REQUEST FOR TENDER No. 20-062

Meadowood Community Centre Construction

**Addendum 3 (16 pages)
Issued: November 30, 2020**

ADDENDUM – 03

<p>DESIGN DRAWING Revised</p>	Email: design@galleyworks.com Ph: 604-514-1777	Project: Meadowood Community Center Community Kitchen	File: 703 Scale: 1:48	Dwg No.: FSE-3
	Title: Food Service Equipment Mechanical Services	Dr: EB Date: 20/10/06	Sheet of: 3 Rev: a

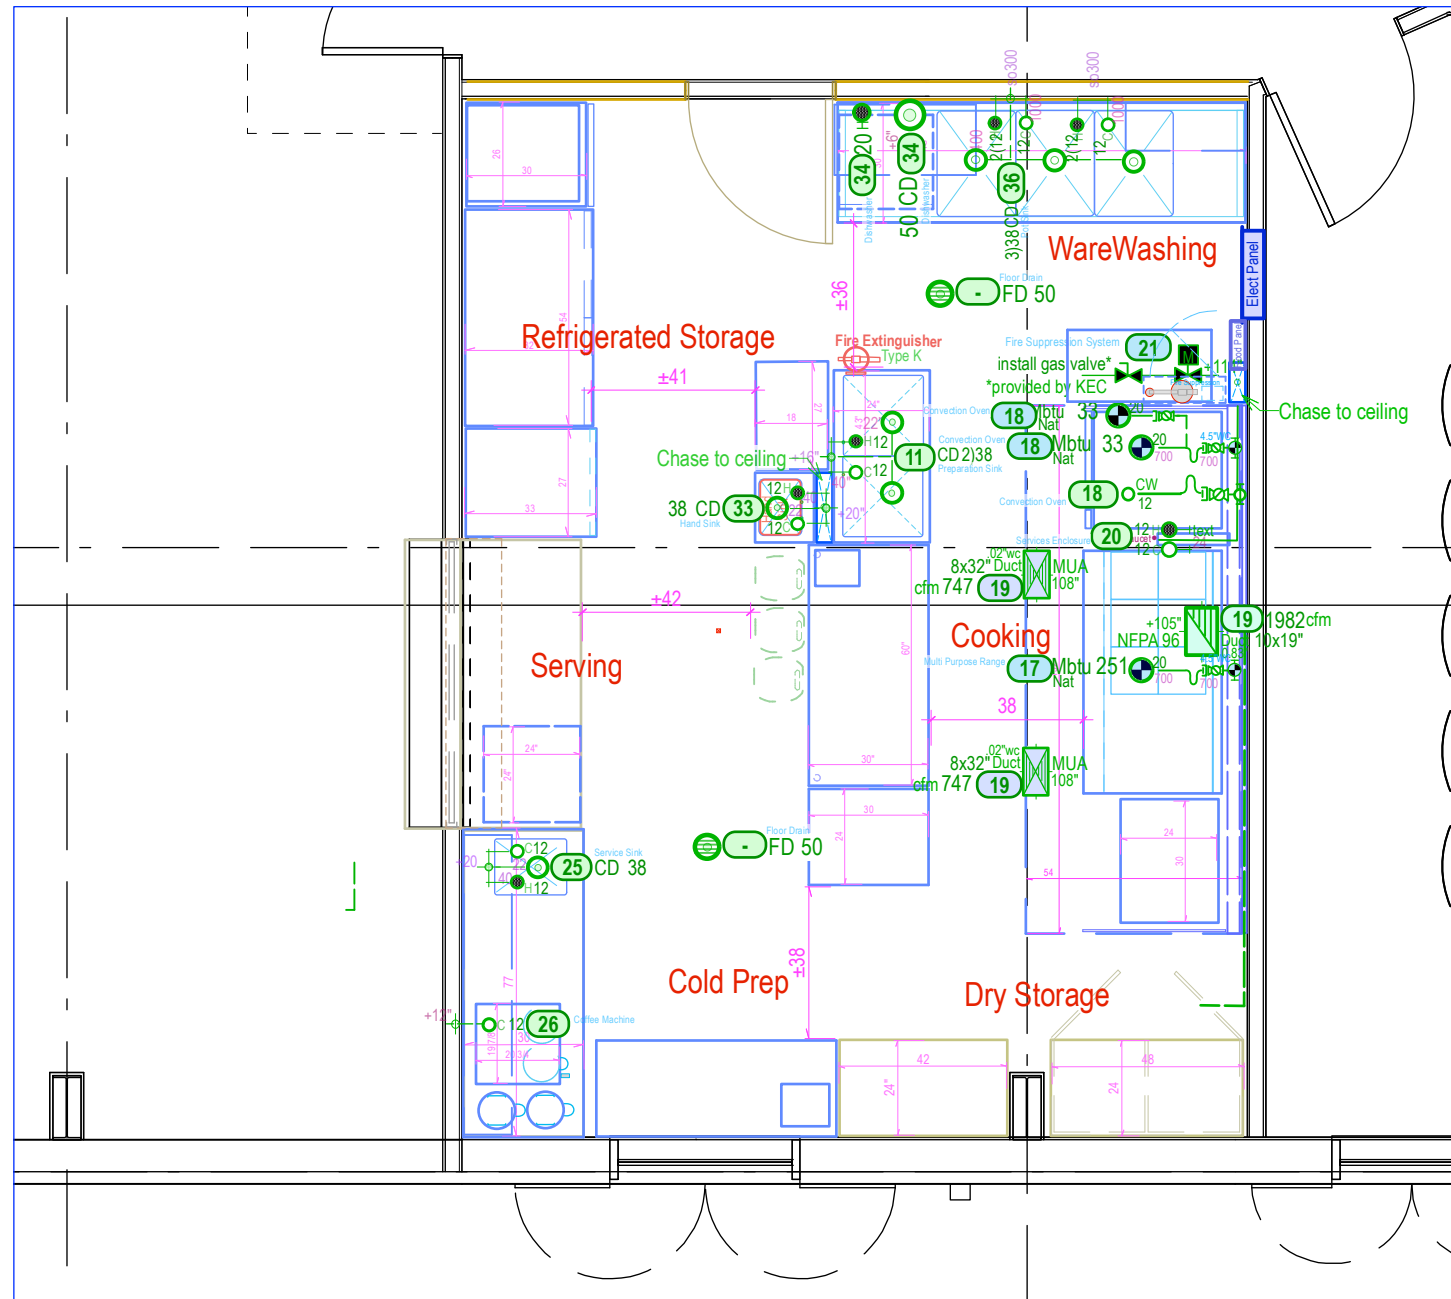
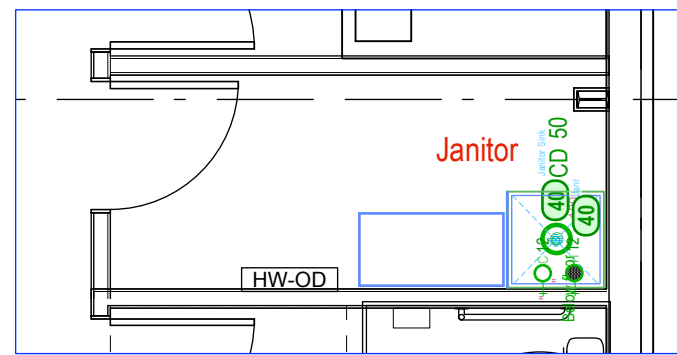
- .4 Food Service equipment as shown and specified on architectural drawings is to be part of the General Contractors Tender Bid Price
 - .1 Additional information FSE 2 to FSE 4 are attached to this Addendum
